# Access Compliance Report Public Rights-of-Way (Curb Ramps)

Intersection ID: 3992	Main Street: BENTHAVEN_LN	Cross Street: BROWNE'S_FERRY_RD	Location: SE
ADA ID: F3D224A61BAB	Ramp Type: Perp	Initial Pass/Fail: Pass	Overall Compliance: No Severity Score: 10

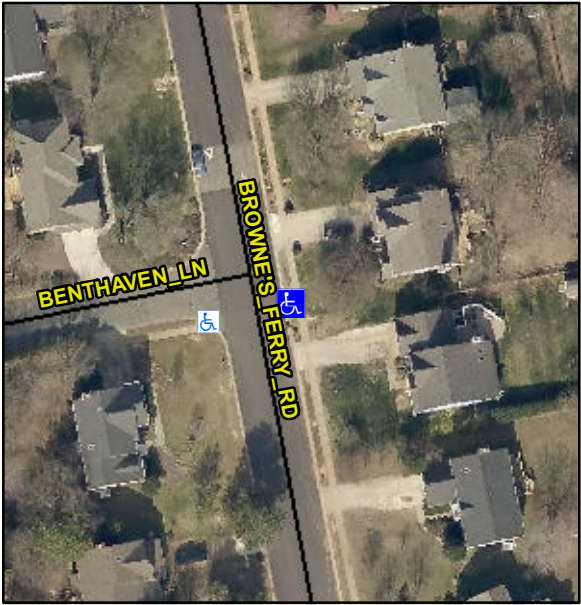
PROW/ADA:  
**Not Found, R304.2.2-Perp, R304.3.2-Para, R304.5.3, R305**

Compliance	Description	Data	Compliance	Description	Data
N/A	Ramp Length (in)	48.0	Yes	Ramp Slope (%)	7.8
Yes	Ramp Width (in)	48.0	Yes	Ramp XSlope (%)	1.7
N/A	Flare Type LT	Sloped	N/A	Flare Type RT	N/A
N/A	Flare Slope LT (%)	6.0	Yes	Flare Slope RT (%)	7.9
N/A	Flare Traversable LT?	Yes	N/A	Flare Traversable RT?	Yes
Yes	Landing Length (in)	48.0	No	DWS Provided?	No
Yes	Landing Width (in)	64.5	N/A	DWS Contrast?	No
No	Landing Slope (%)	3.4	N/A	DWS Length (in)	N/A
No	Landing X Slope (%)	2.4	N/A	DWS Full Width?	No
N/A	Landing Curb? (Y/N)	No	N/A	DWS Offset (in)	N/A
N/A	Shared Landing?	No			
Yes	Gutter Ponding?	No	Yes	Gutter Slope (%)	1.9
Yes	Gutter Lip Ht (in)	0.0	Yes	Gutter X Slope (%)	1.1
N/A	Painted X Walk1?	No	N/A	Painted X Walk2?	N/A
	X Walk 1 Direction	To W		X Walk 2 Direction	N/A
N/A	X Walk 1 Width (in)	N/A	N/A	X Walk 2 Width (in)	N/A
	X Walk 1 Slope (%)	5.8		X Walk 2 Slope (%)	N/A
	X Walk 1 X Slope (%)	1.2		X Walk 2 X Slope (%)	N/A

N/A	Ramp inside XWalk1?	N/A	N/A	Ramp inside XWalk2?	N/A
	Road Slope (%)	N/A	N/A	Clear Space?	Yes
	Road X Slope (%)	N/A	N/A	Clear Space to XWalk (in)	N/A
Yes	Any Obstructions?	No	Yes	Storm Grate/Utility Hazard?	No
	Obstruction Type			Storm Grate/Utility Type	
		N/A			N/A
			Yes	Surface Condition? (G/P)	Good

Possible Solutions:  
**Remove & Replace Entire Ramp.**
